CONWAY

HISTORIC DISTRICT COMMISSION
SEPTEMBER

6:00pm • September 26, 2016 • City Hall

Asa P. Robinson Historic District & Old Conway Design Overlay District

New drawings show:

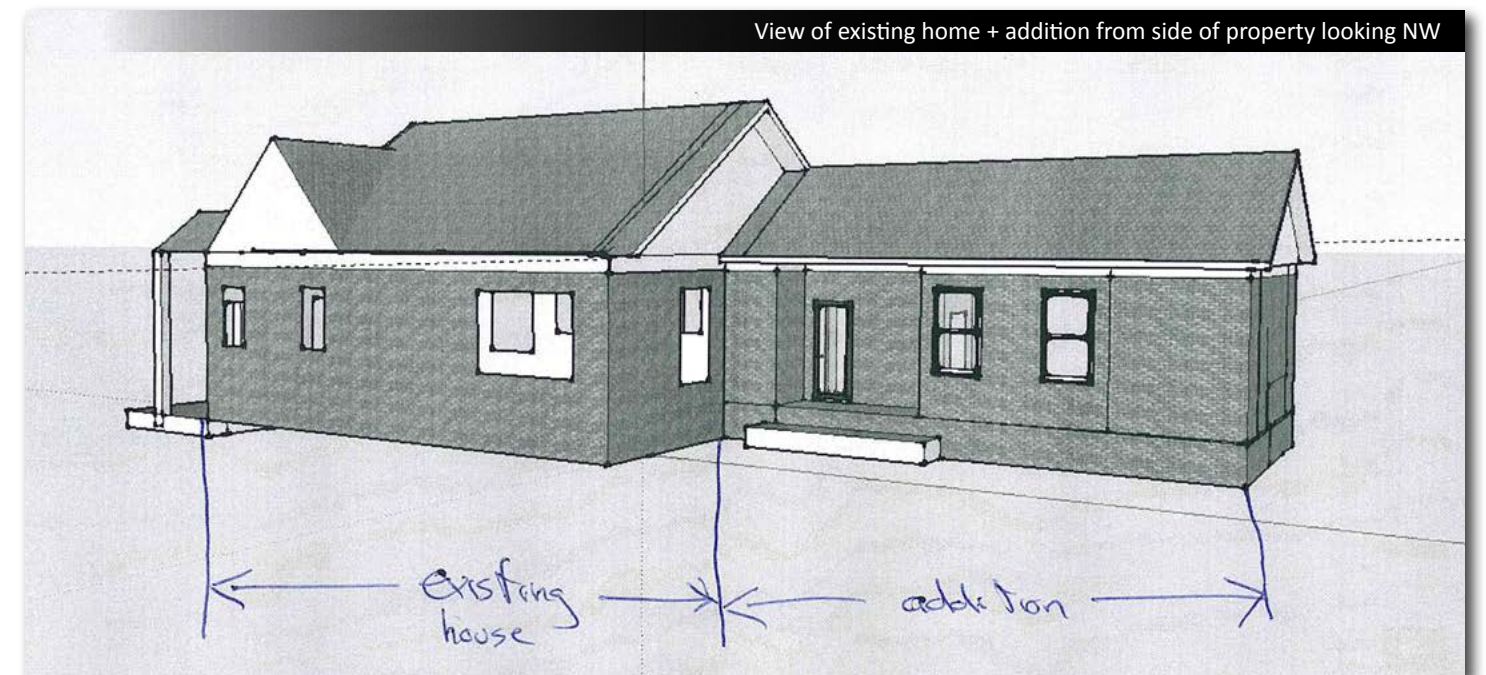
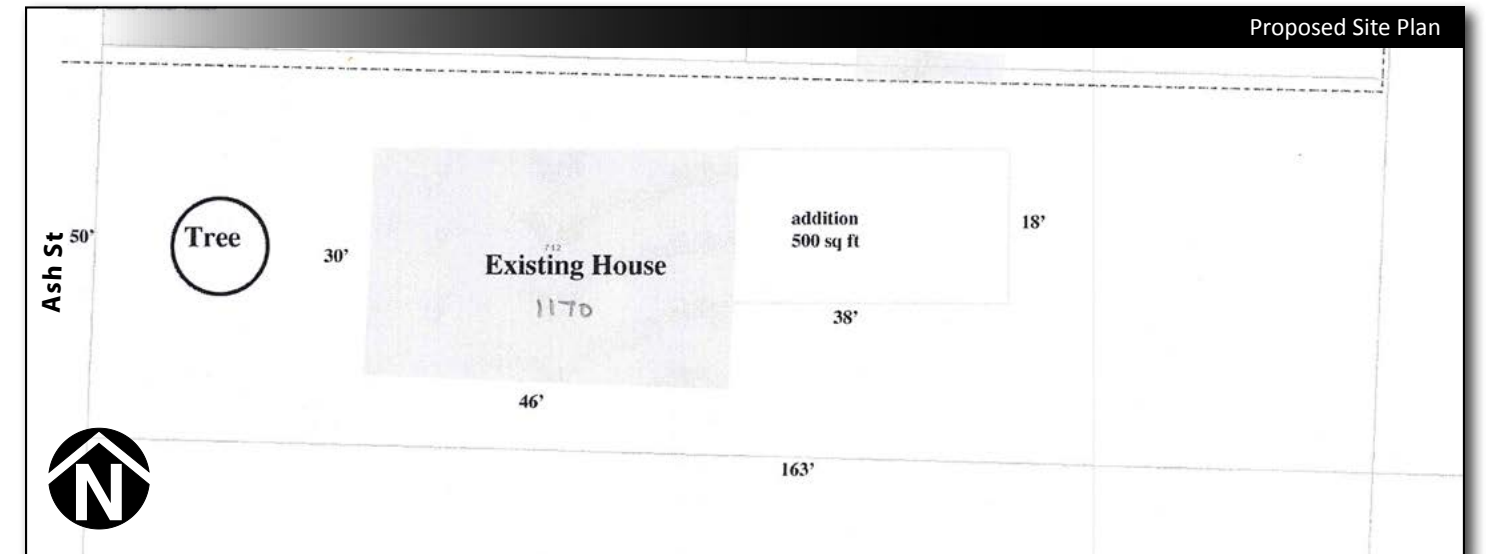
The item was held in committee at the August HDC meeting as the Commission felt additional information was needed and that the submitted drawings were too schematic. New drawings with additional information have been submitted for September.

- *The addition will be clad in brick. The existing brick and addition's brick will be painted so that the entire house matches.*
- *Eaves and soffit will be sided with Hardie-board to match the existing house.*
- *Two windows and one door are shown on the addition's south elevation. The windows will match the scale and style of existing windows. A concrete stoop is also shown.*
- *No windows are planned on the addition's east and north elevations. These elevations will be out of the public view.*

- *The existing door and small porch/portico will remain unchanged. The carport proposed in August will not be constructed at this time.*
- *New roof will match existing asphalt shingle roof.*
- *A skylight may be used on the north facing roof to provide natural light to the bathroom.*

1. The addition, open carport, and driveway shall be constructed as shown in submitted plans.
2. The addition will be clad with brick closely matching the existing residence.

3. A 10 foot concrete driveway may be constructed on the north side of the residence.
4. An open carport with a "0" foot setback shall be allowed on the north side of the residence.
5. Addition windows and doors?
6. The repair and restoration of the existing original windows is strongly encouraged.

Perspective showing rear porch addition

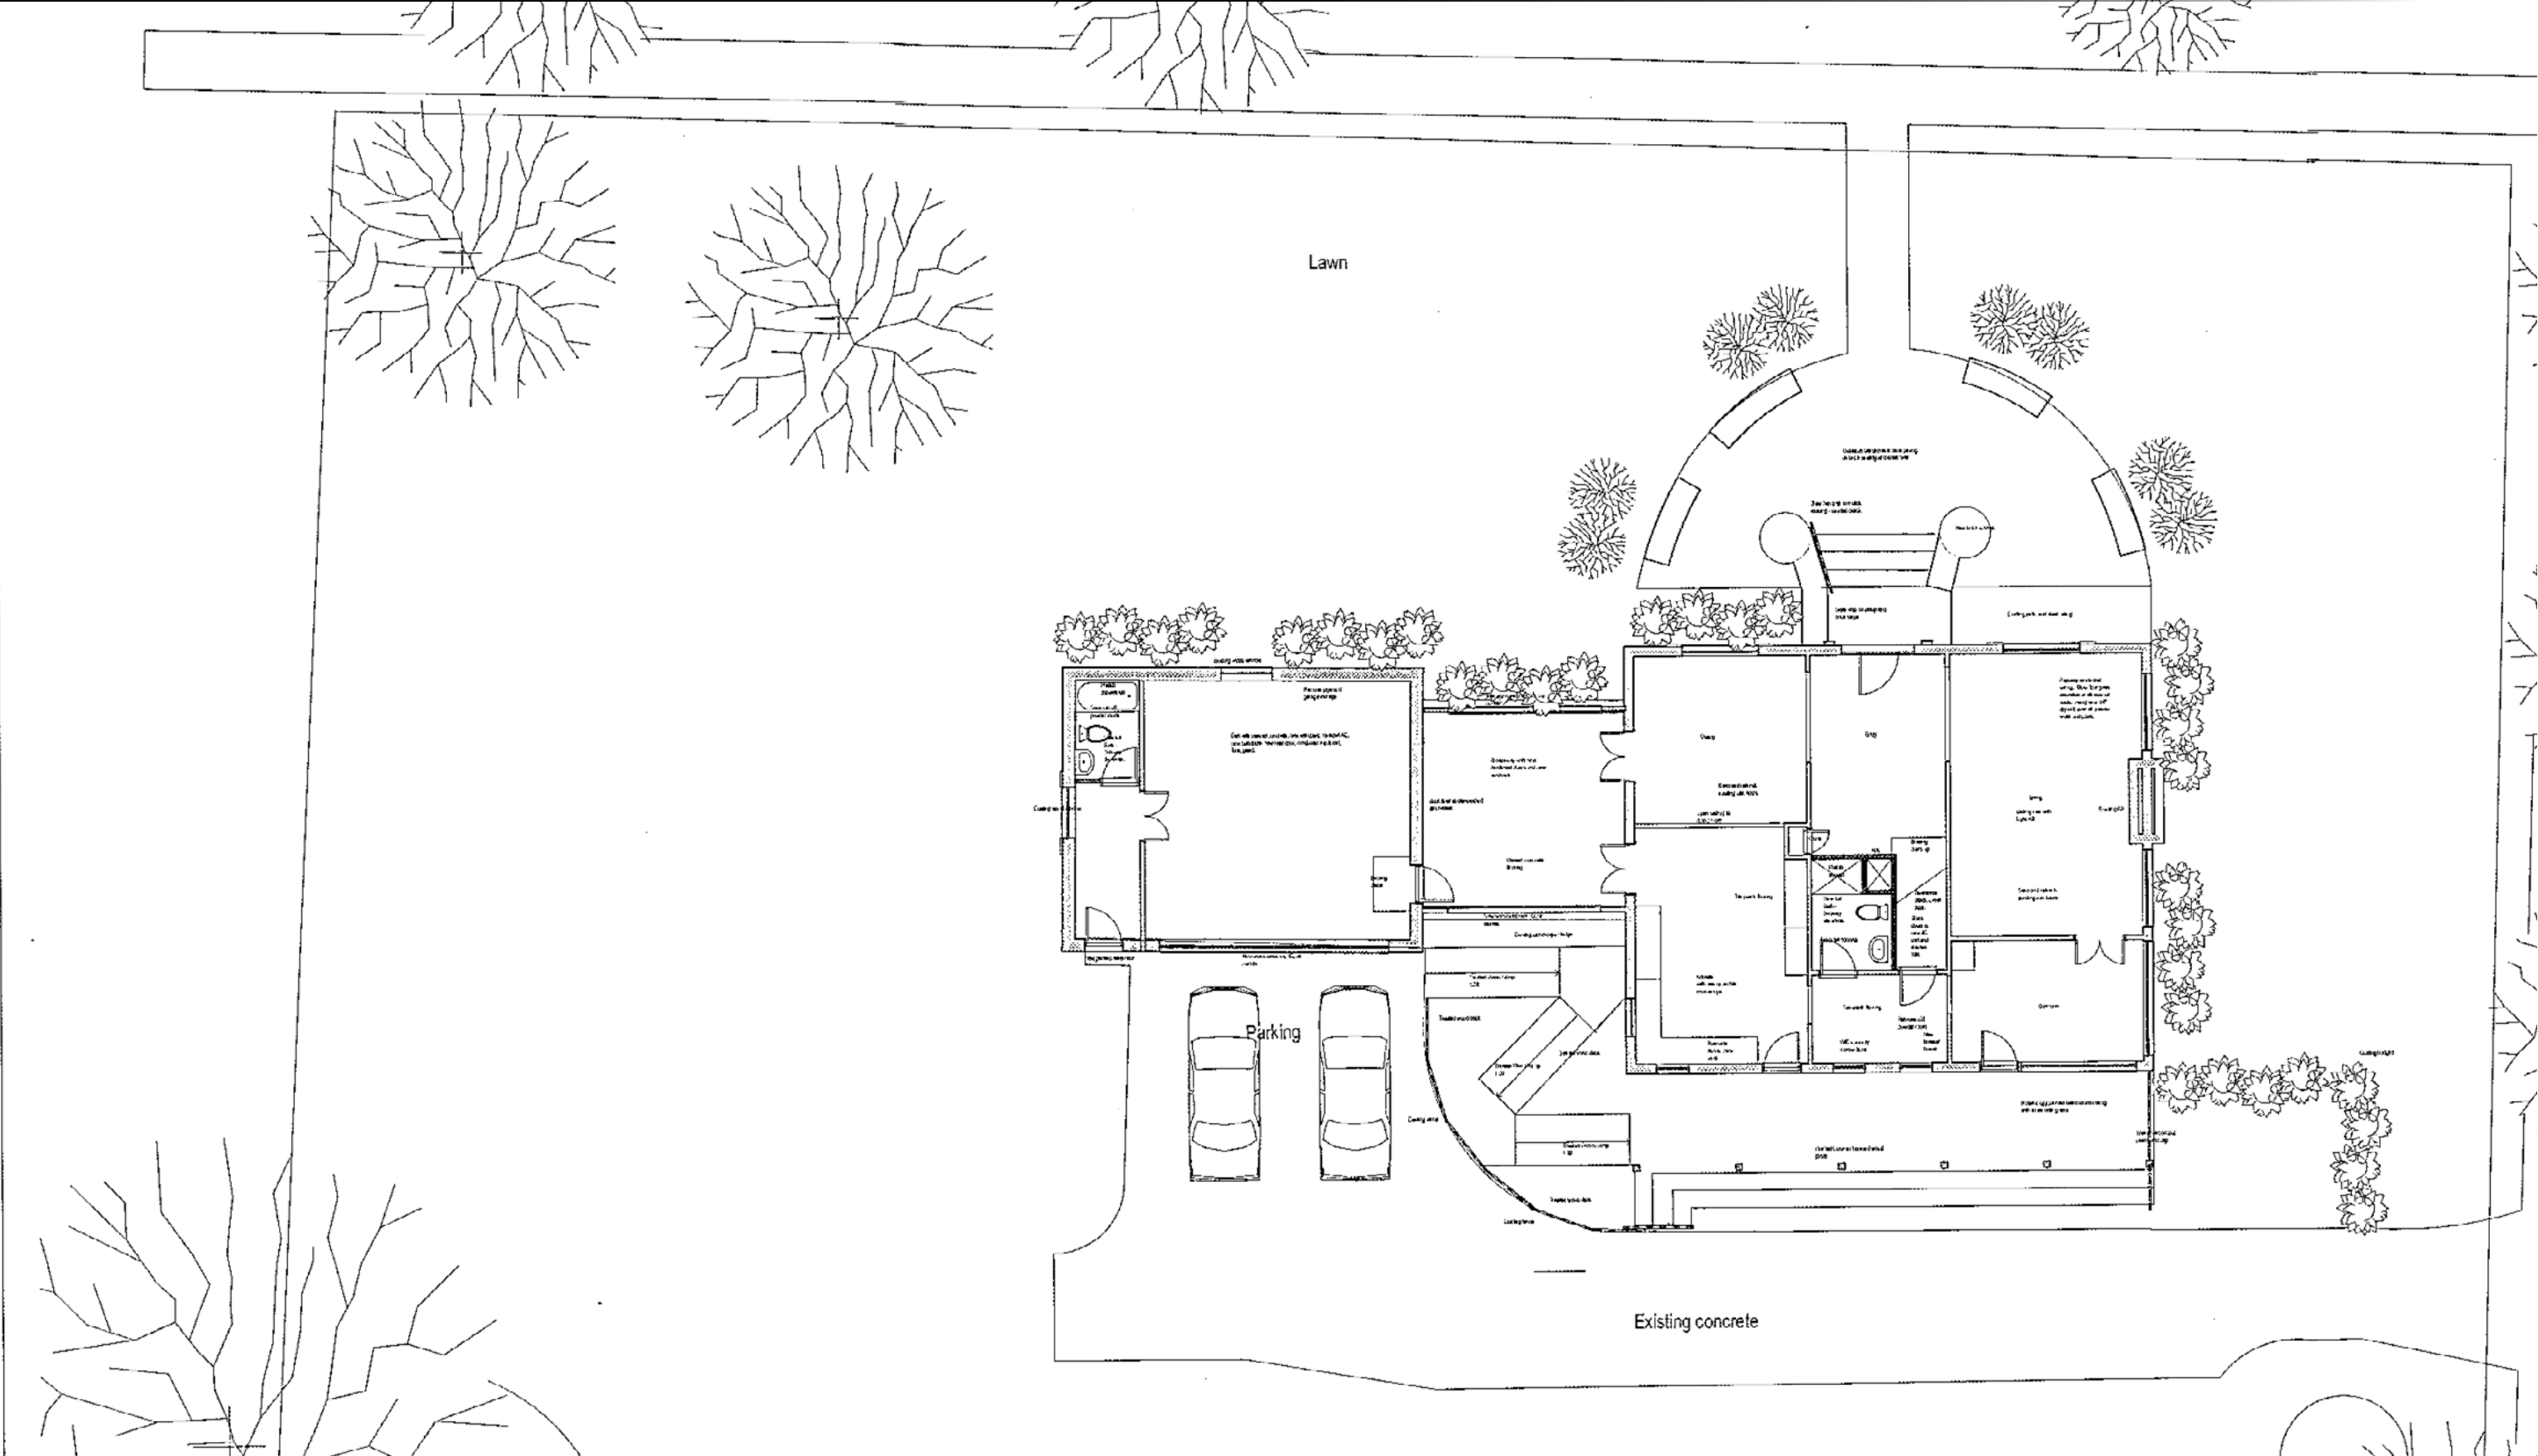
Facade, wall area, rhythm. Facades shall be compatible with surrounding historic structures in proportion of wall to opening area. The proposed porch will change the rear facade, however the rhythm of the porch columns creates a classic vernacular porch.

1. The porch and plaza additions shall be constructed as shown in submitted plans.
2. The plaza space brickwork shall use brick closely matching the existing residence.
3. The repair and restoration of the existing original windows is strongly encouraged.
4. New windows in the breezeway are shall match existing historic windows.
5. New porch roof shall match existing asphalt roof.

LEFT ELEVATION
SCALE 1/4 = 1'-0"

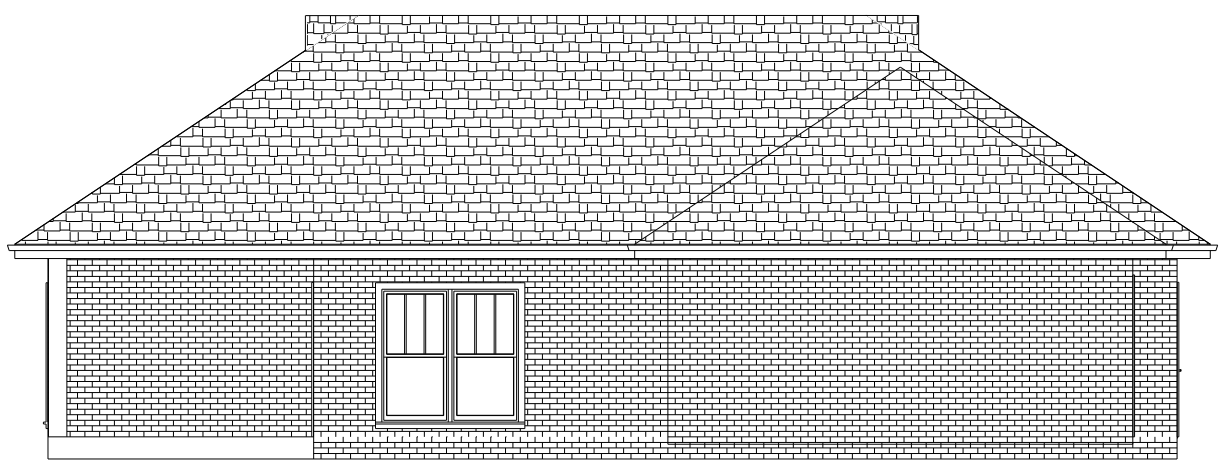
Doors and windows. The rhythm, patterns, and ratio of voids to solids of new buildings should relate to and be compatible with adjacent facades; typically a higher proportion of voids to wall area. The new residence has a large amount of windows on the front facade. The other elevations are lacking in windows. The rear elevation is unseen, however, the left and right elevations should have one window added to each side in the bedrooms.

1. The residence and driveway shall be constructed as shown in submitted plans.
2. The residence will be clad with brick and ? siding.
3. Two additional windows shall be added; one to the left elevation (master bedroom) and one to the right elevation (front bedroom).
4. Roof shall be asphalt composition roof.
5. A 2" caliper tree will be planted in the front yard to remediate the removal of a significant tree.

1 WEST ELEVATION
1/8" = 1'-0"

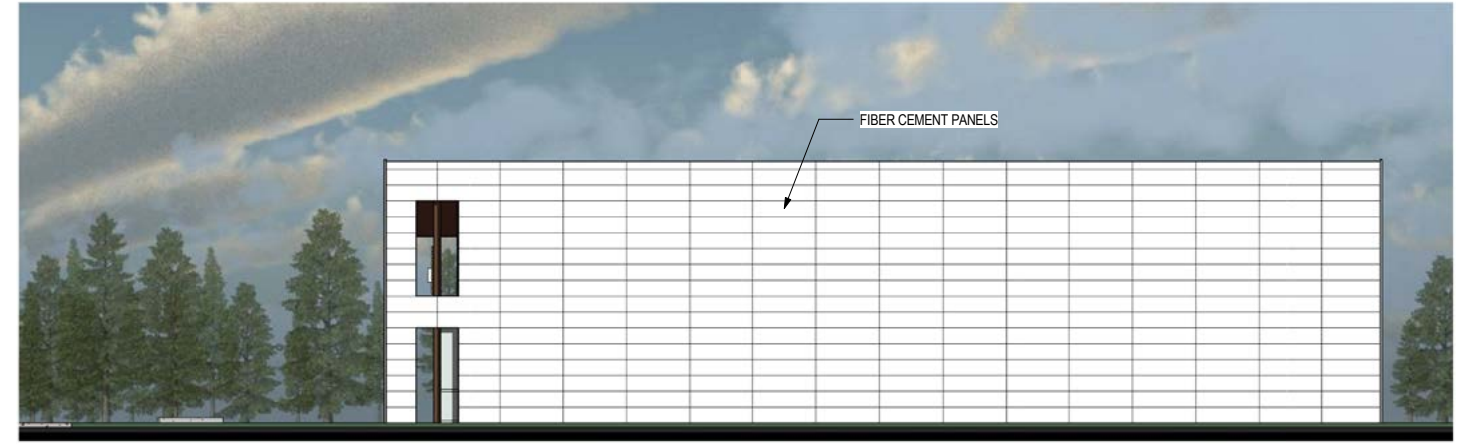
Height. The average height of area structure’s eaves and cornices. Also, the first floor elevation / height relationship. The proposed building will be one story. The NEOCA plan calls for a 2 story minimum height with a ground floor to ceiling of 15 feet. The overall height of the building will be that of a 2 story, but will only have 1. First floor to ceiling height is also appropriate.

Complexity of form. The level of detailing and breaks in wall planes of a structure. Breaks in the wall planes are created through the use of columns, protruding glass areas, horizontal lattice, and a cantilevered roof. The south elevation is blank, however, it is largely unseen behind the existing Baker medical building.

- Staff recommends approval with the following conditions:
1. The medical office building and parking lot shall be constructed as shown in submitted plans.
 2. Setbacks as shown on submitted plans will be allowed.
 3. The structure may be one story with the appropriate 2 story height as shown on submitted plans.
 4. On street parking shall be allowed per City Engineer approval.
 5. Sidewalks shall be constructed as shown on submitted plans with the Oak/Harkrider Street detail along Harkrider. This sidewalk and construction details shall be coordinated with the City and utilities.

Streetscape - Street Design - Shading

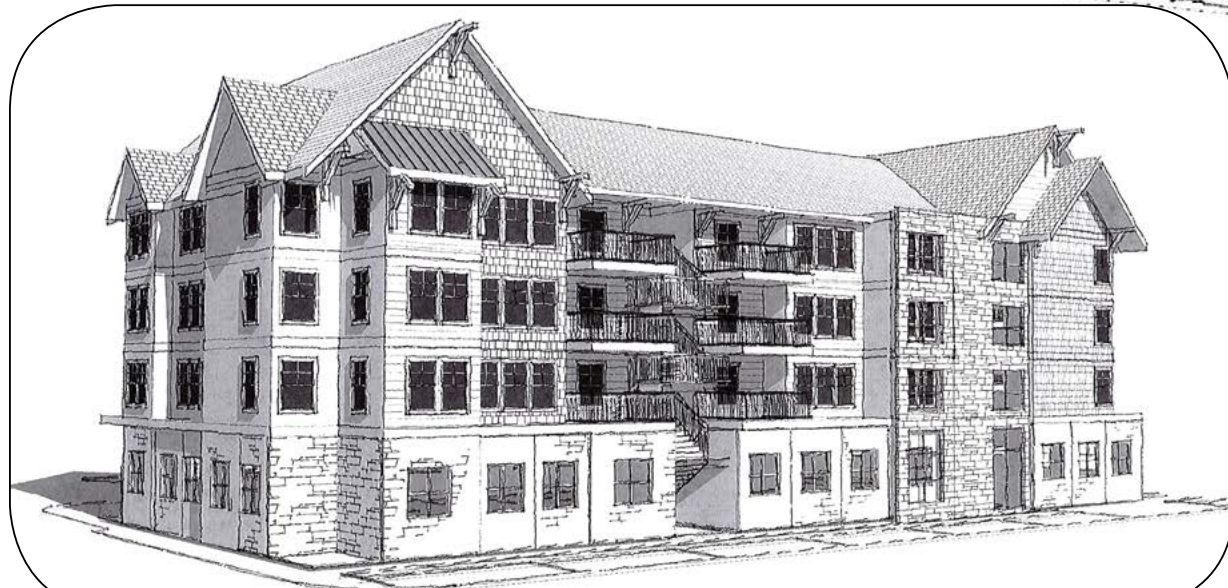
The MSNSP regulations place specific emphasis on the urban streetscape including shading from trees and/or awnings, on street parking, street lighting, street landscaping, etc. The City is designing and constructing an appropriate street design including parallel parking, landscaping, trees, lighting, wide sidewalk where possible, etc. The streetscape requirements of the MSNSP will be met with this design and construction.

1. Ground floor parking shall be allowed under the structure in Layers 1, 2, and 3.
2. A 0 foot building setback shall be allowed on all sides of the structure.
3. Siding materials including ? shall be allowed as shown on the submitted building elevations and perspectives.
